ISSUED ADDENDUM

Date	6/18/2020
Addendum Number	1
Project Number and Name	218042 Demolish and Replace Barracks and Latrine Facilities 02108-02113
Invitation to Bid Date	5/13/2020
Number of Attachments	7
Bid Opening Date and Time	6/25/2020 (2:00 PM – St. Augustine, FL)

ADDENDUM NO. TWO

**DEMOLISH & REPLACE BARRACKS & LATRINE FACILITIES 02108-02113
CAMP BLANDING JOINT TRAINING CENTER
STARKE , FL
For FLORIDA DEPT. OF MILITARY AFFAIRS**

C-4.0
 BID SUBMITTAL

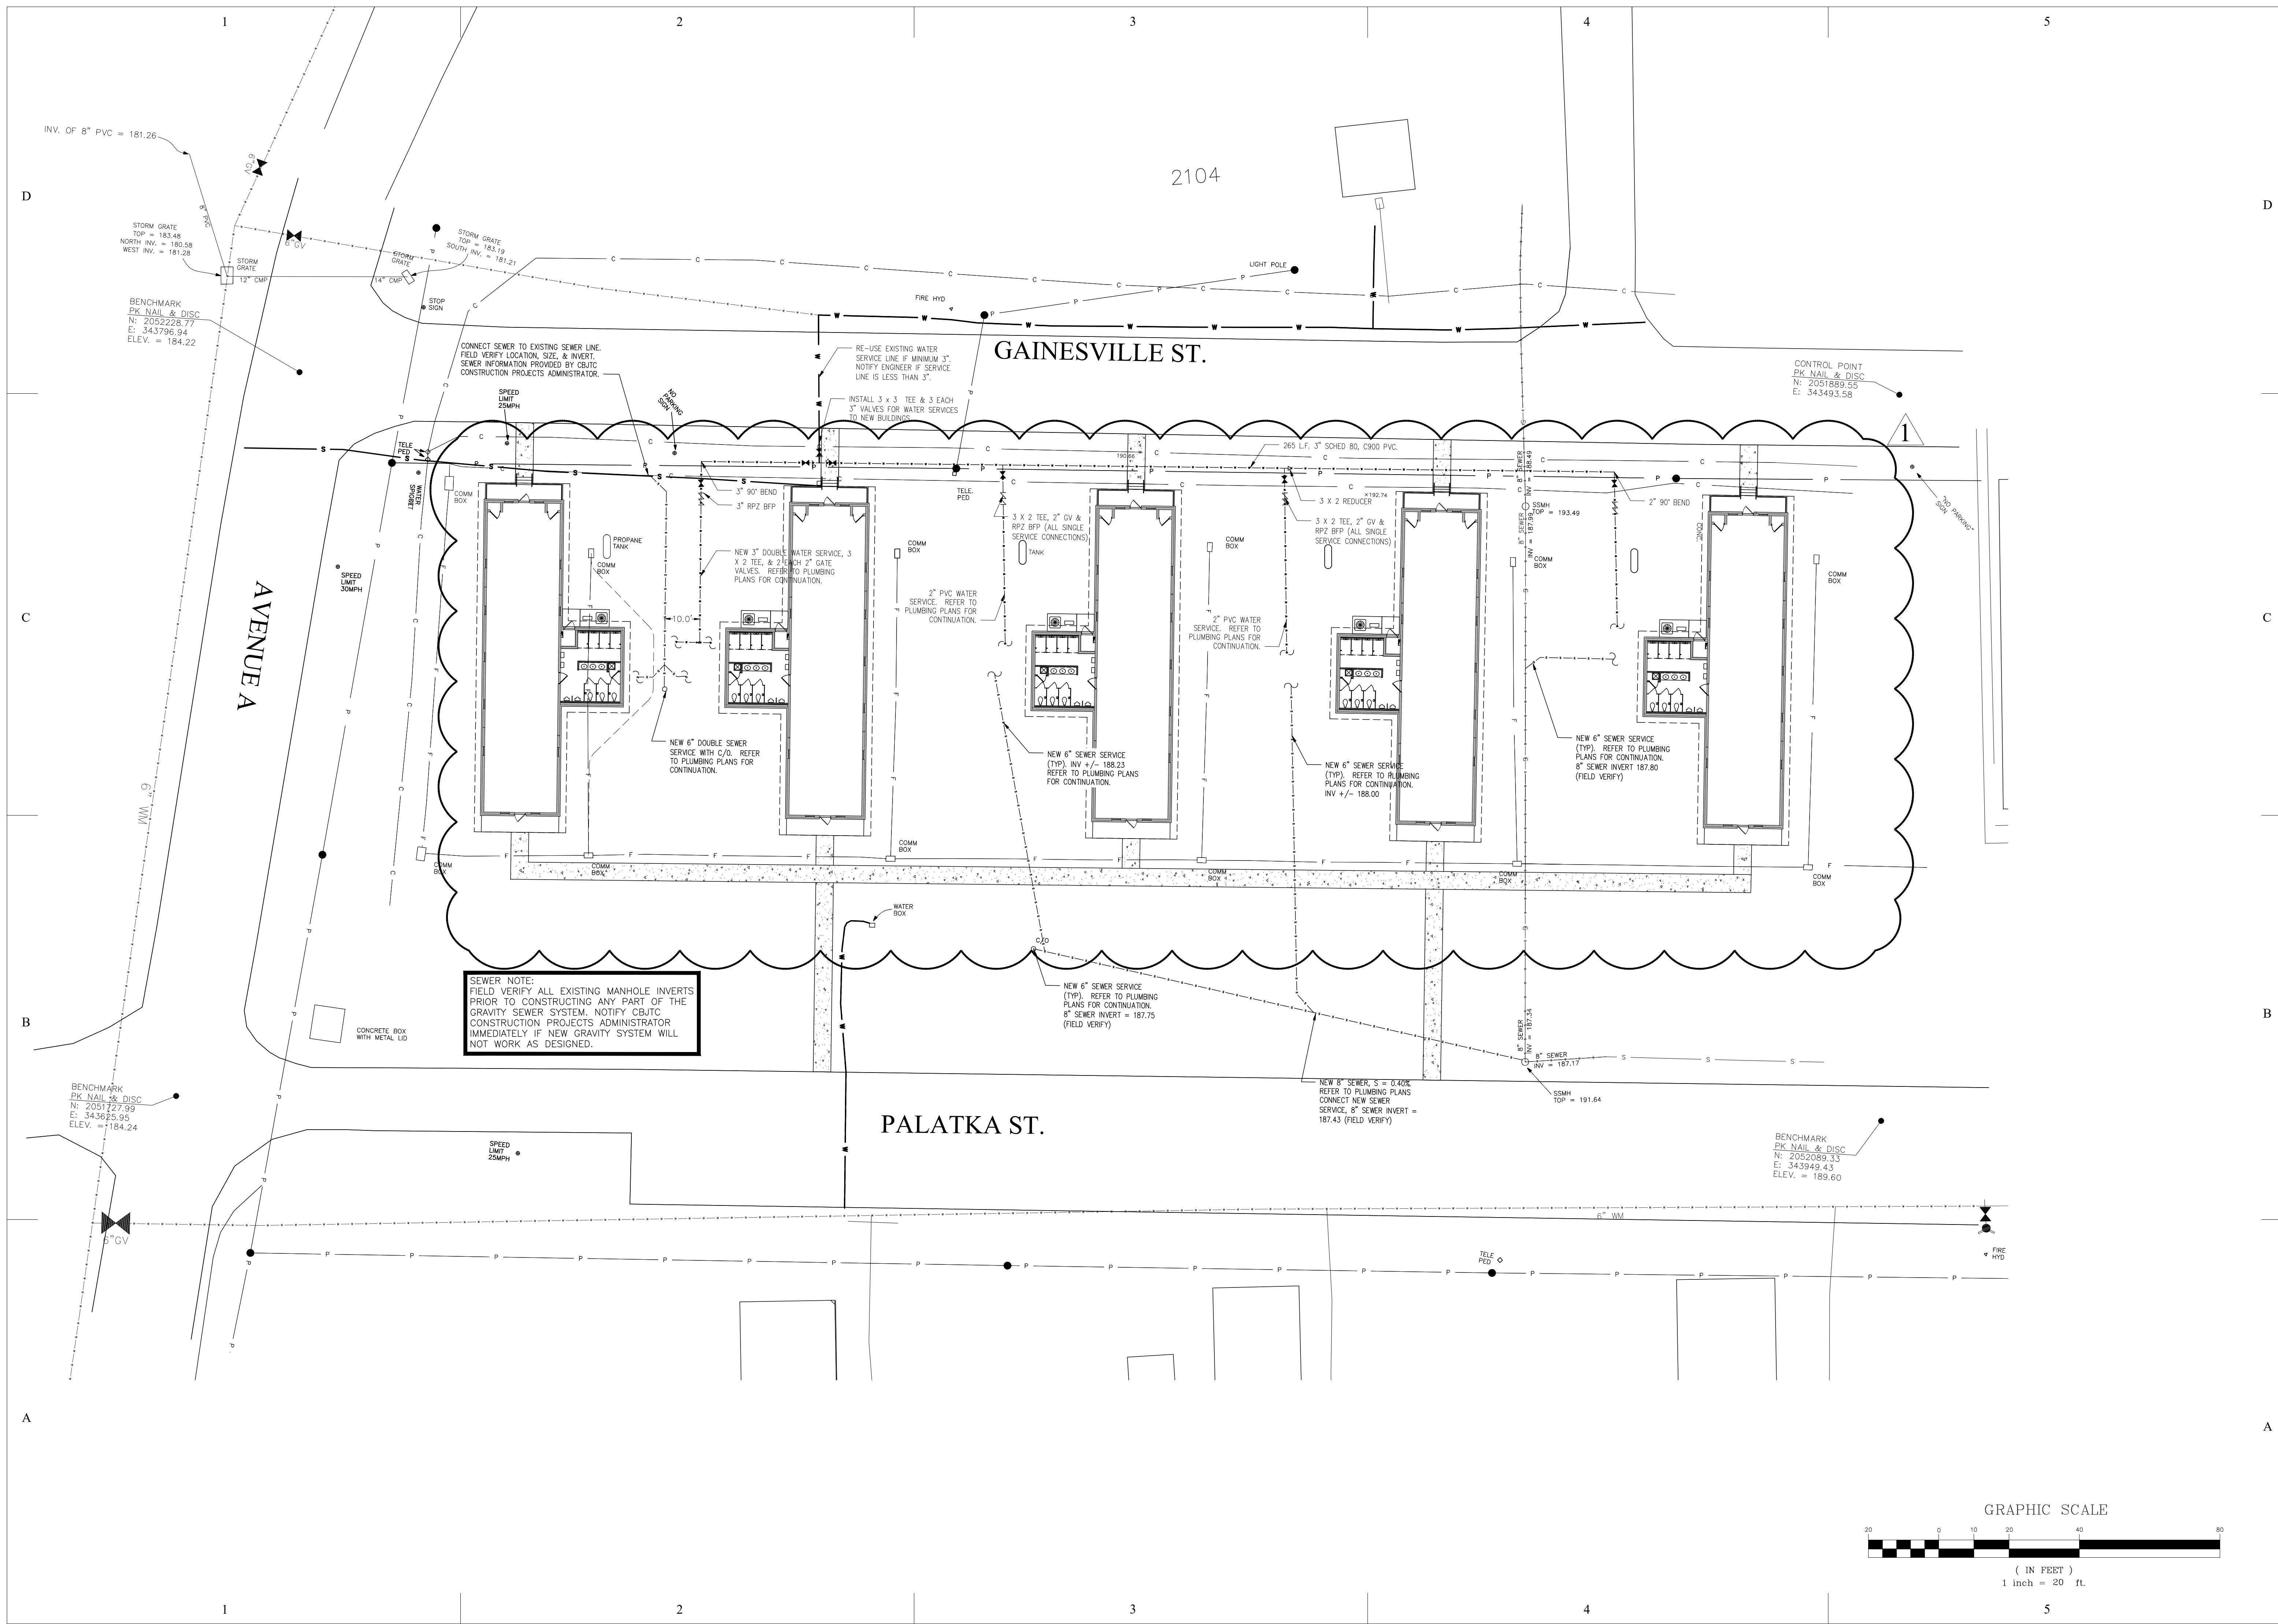
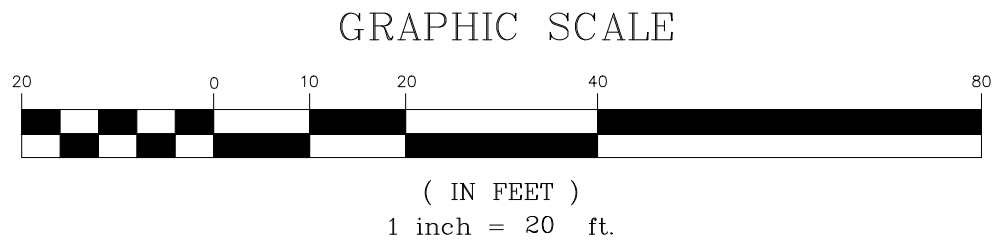
Sheets C-2.0, C-3.0, C-3.1 and C-4.0 have been revised in order to provide additional information and clarification in response to questions asked in RFI #002. Please see RFI #002 reply for additional information.

1. It appears slab orientation on civil drawings is reversed from architectural drawings. Please clarify.

Response: Orientation of buildings shown on architectural drawings is correct. Please see revised civil drawings C-2.0, C-3.0 and C-4.0 issued by Addendum #002 for updated information.

A101
 BID SUBMITTAL

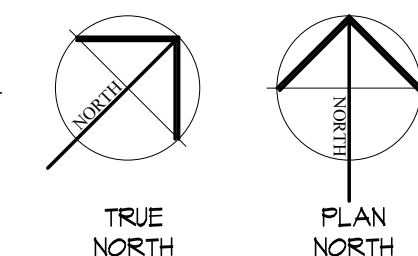
Sheet A101 has been revised in order to provide coordination with revised civil drawings issued as part of the response to RFI #002.
